Client:
SEH PUB PARTNERSHIP

Project:
300 BARLOWMOOR ROAD
CHORLTON

Drawing Title:
PROPOSED SITE PLAN

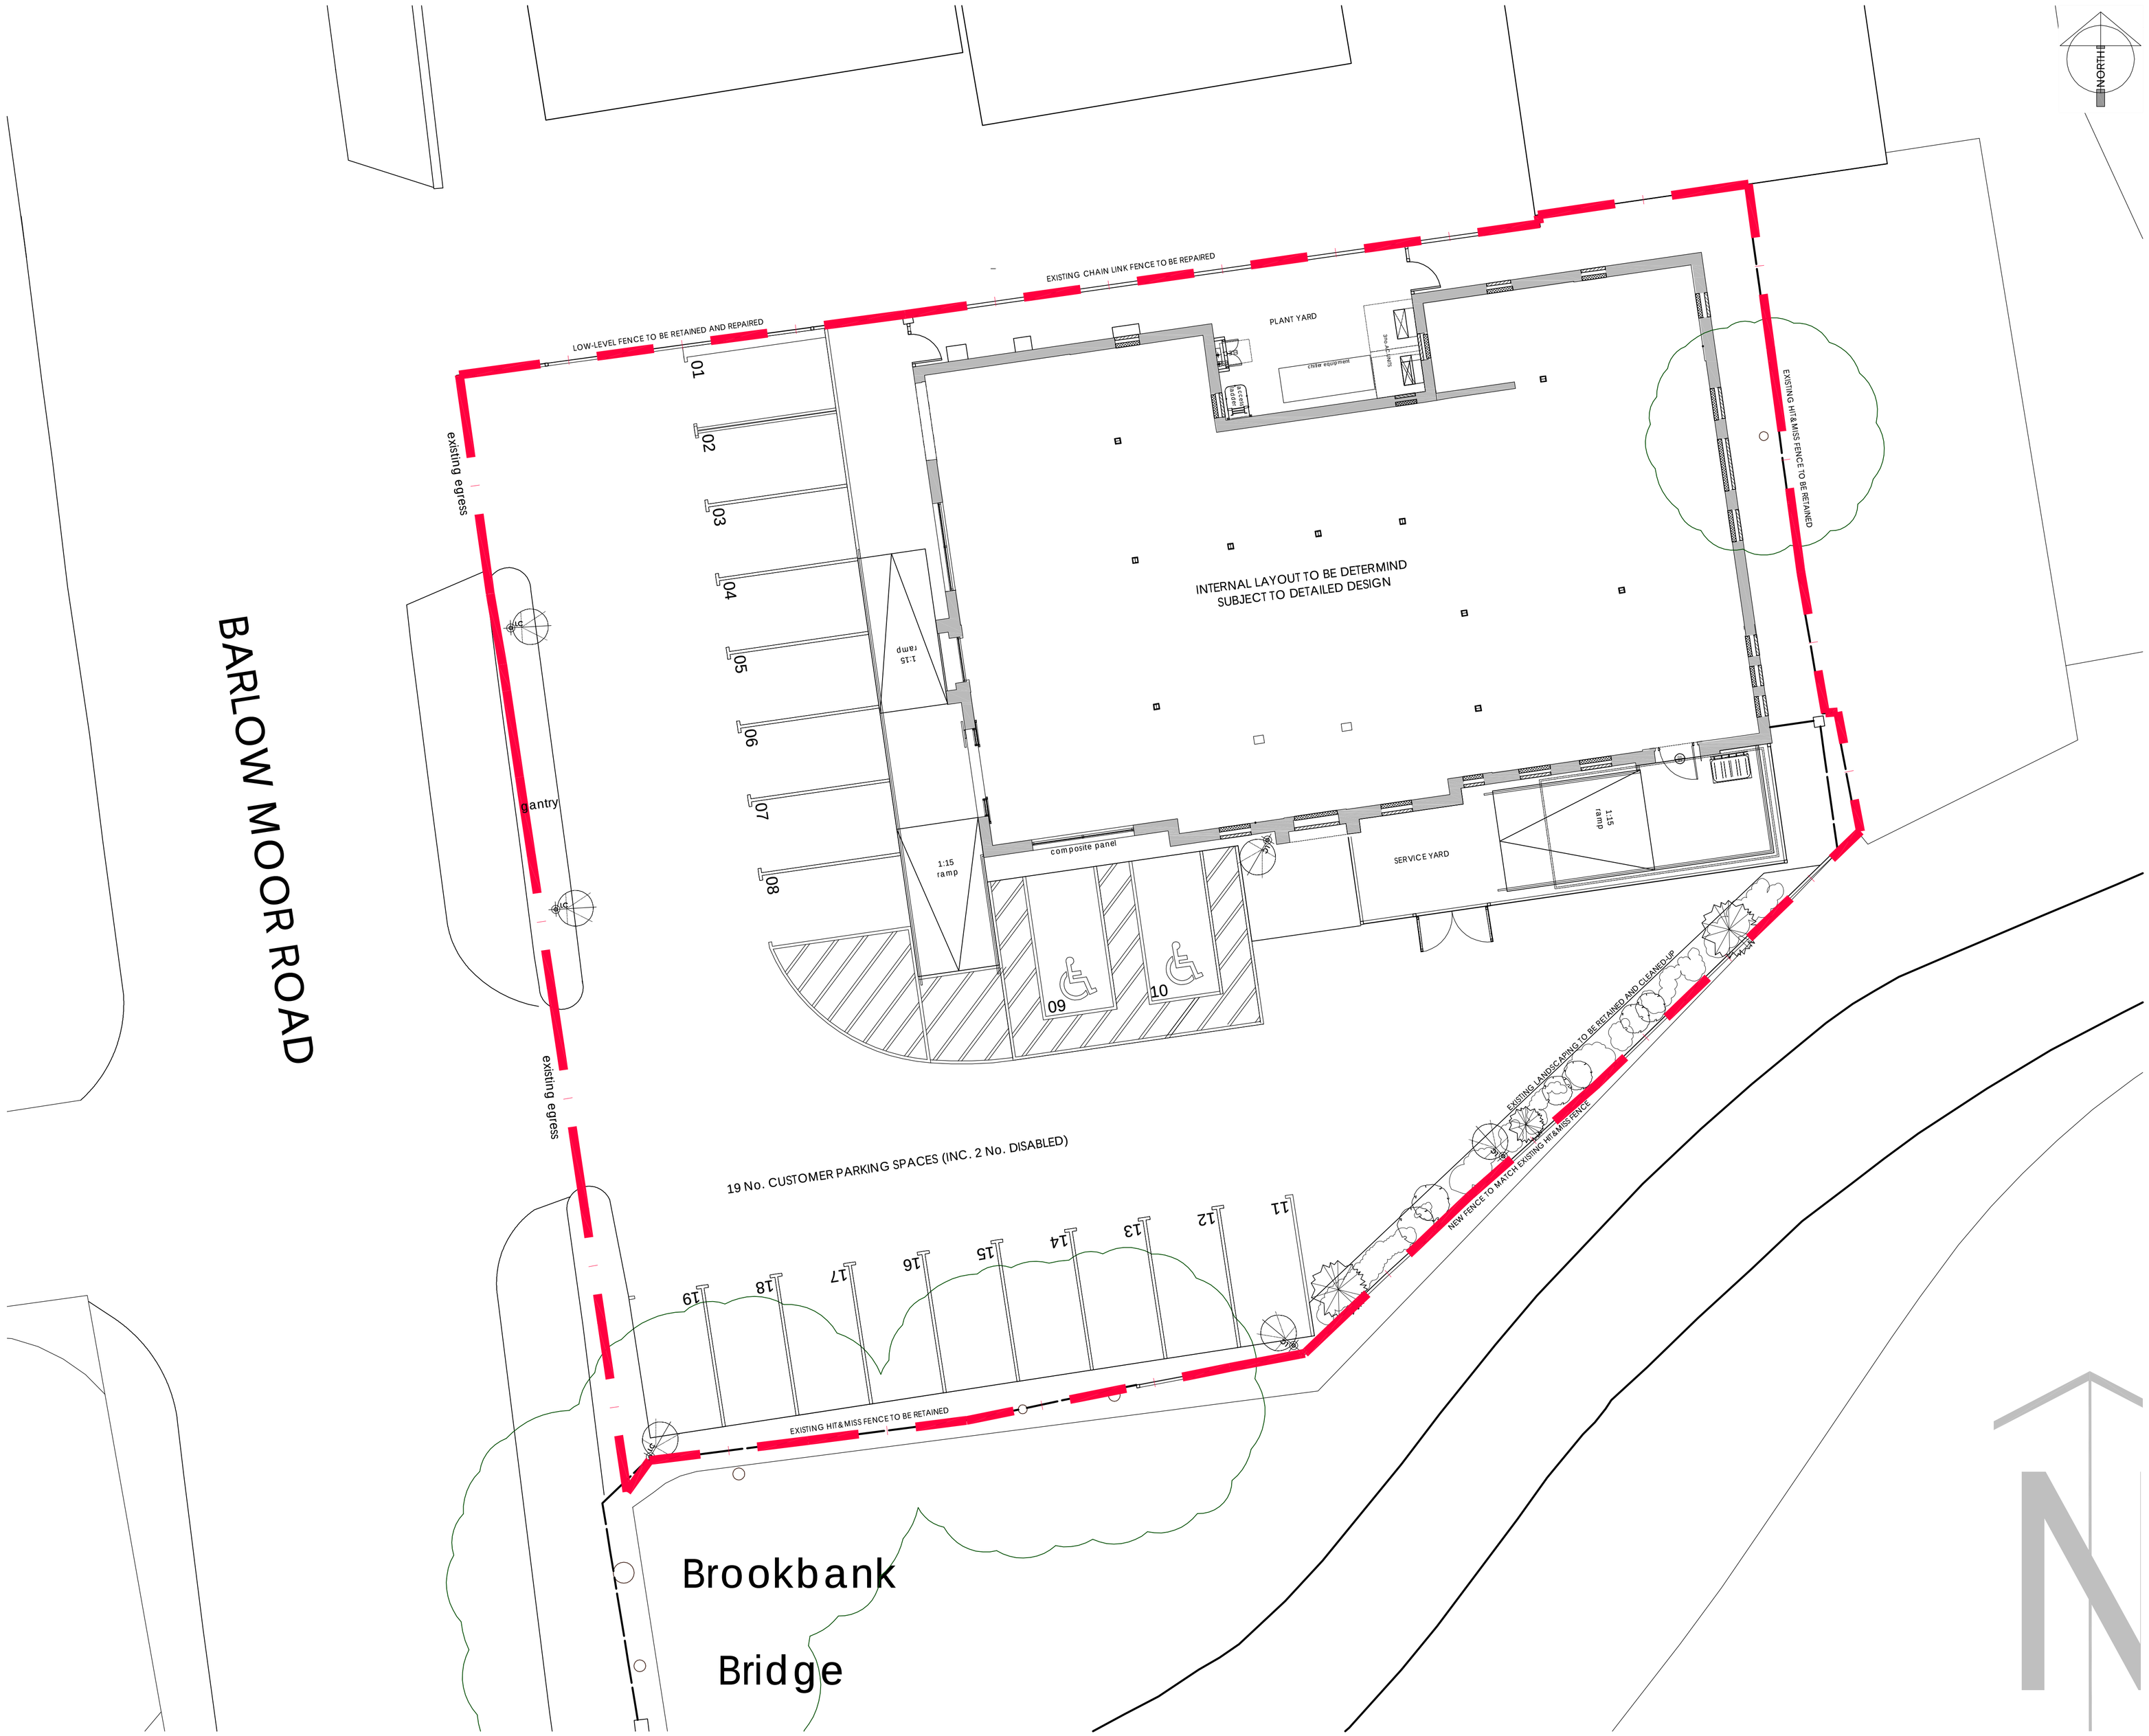
Revision:	By	Approved
A 26.05.10 The following amendments made: 1 - Parking spaces increased to 2.5M 2 - Entrance door modified to suit internal layout 3 - Entrance ramp modified to include two ramps and increased in width. 4 - Glazing to left of the building changed to brickwork 5 - Services ramp modified and increased in width. 6 - Cat ladder added for access to the first floor roof 7 - External electrical cupboard added. 8 - Lanscaping modified to incoroparte existing. 9 - A/c units repositioned to the other side of the building 10- glazing to side elevation changed to composite panel	LH
